# **System Pillar / EULYNX**

## **Baseline Set 4 Release 3**

Version: 3.5  
Date: 15-12-2025

# Annex 1: Error correction CRs

## F\_Control\_4W\_PM

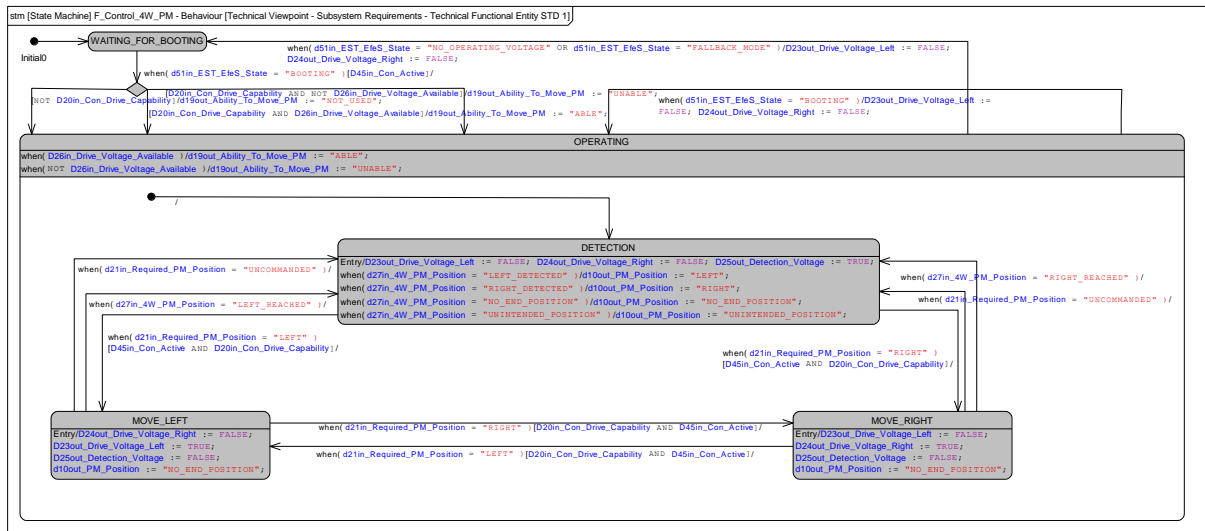
The STM diagram F\_Control\_And\_Observe\_4W\_PM (Eu.P.5823) contains an error. The 2nd transitions from MOVING\_LEFT\_PM / MOVING\_RIGHT\_PM to DETECTION contain `d12in_Required_PM_Position = "LEFT_REACHED" / d12in_Required_PM_Position = "RIGHT_REACHED"`. This condition can never be true, because the values "LEFT\_REACHED" / "RIGHT\_REACHED" are not used for the port `d12in_Required_PM_Position`.

The correct transition must be `d27in_4W_PM_Position = "LEFT_REACHED" / d27in_4W_PM_Position = "RIGHT_REACHED"`.

The correct transitions are shown in the attached figure.

**[EUIO-439] [SDI-IO, correction of multiplicities for PhysicalChannelConnection](#)** Created: 26.07.2024 Updated: 26.07.2024

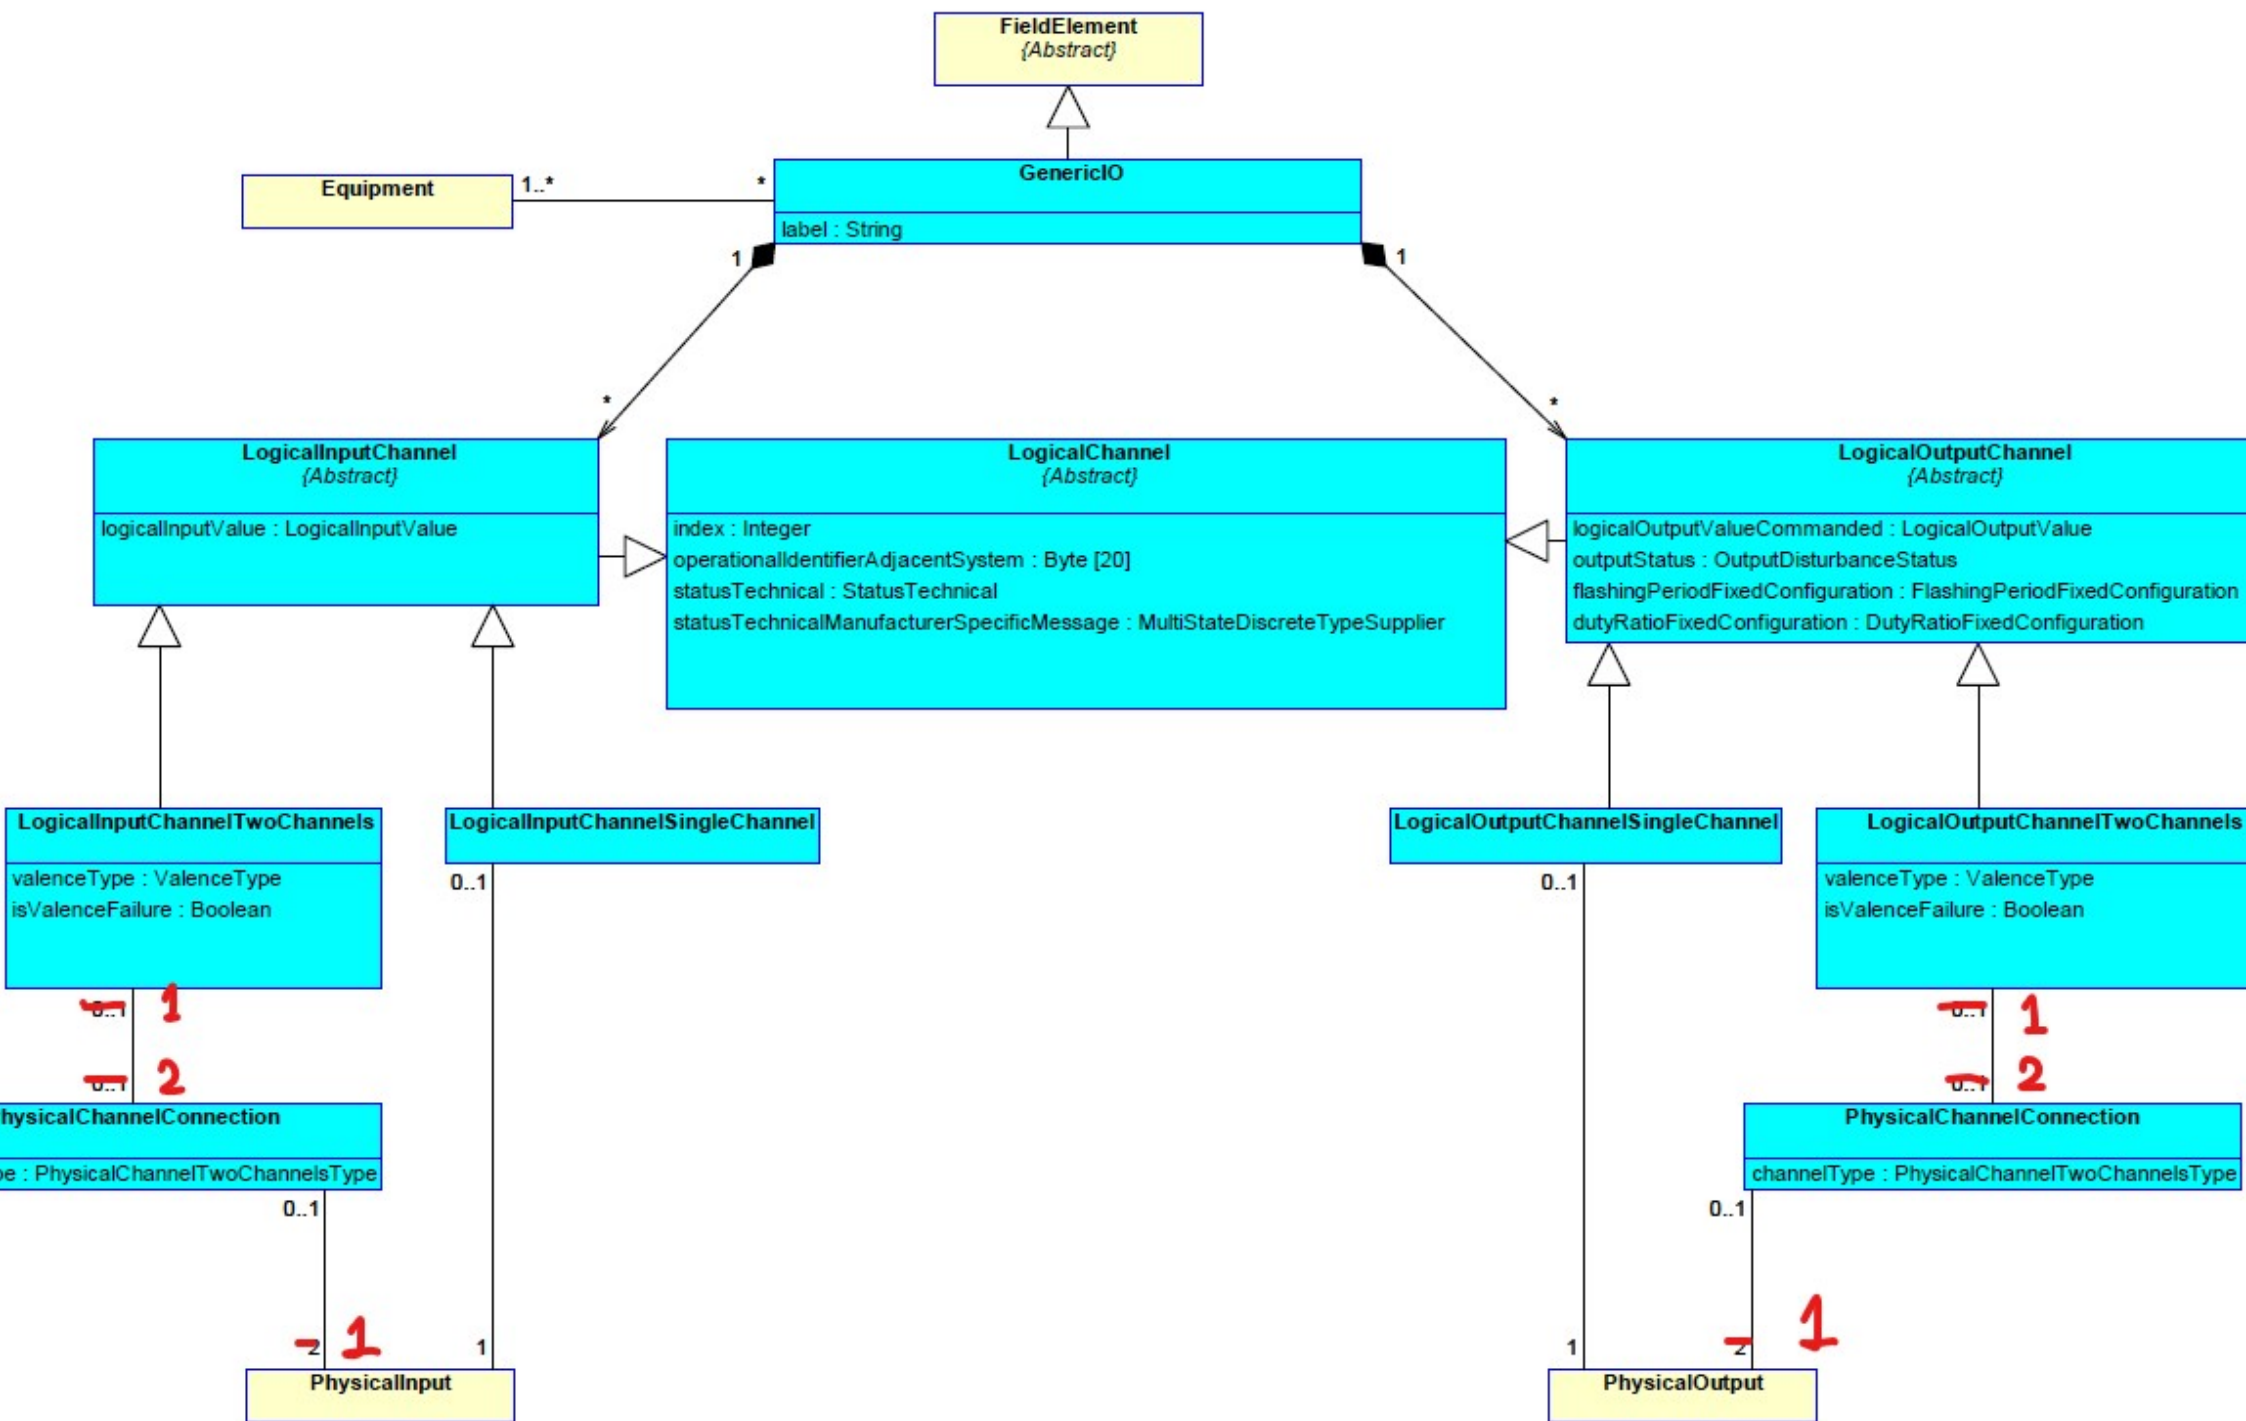
**Problem**  
The multiplicities between LogicalInputChannelTwoChannels, PhysicalChannelConnection and PhysicalInput are incorrect.  
Also valid for the multiplicities between LogicalOutputChannelTwoChannels, PhysicalChannelConnection and PhysicalOutput.

**Intended state**  
See figure.
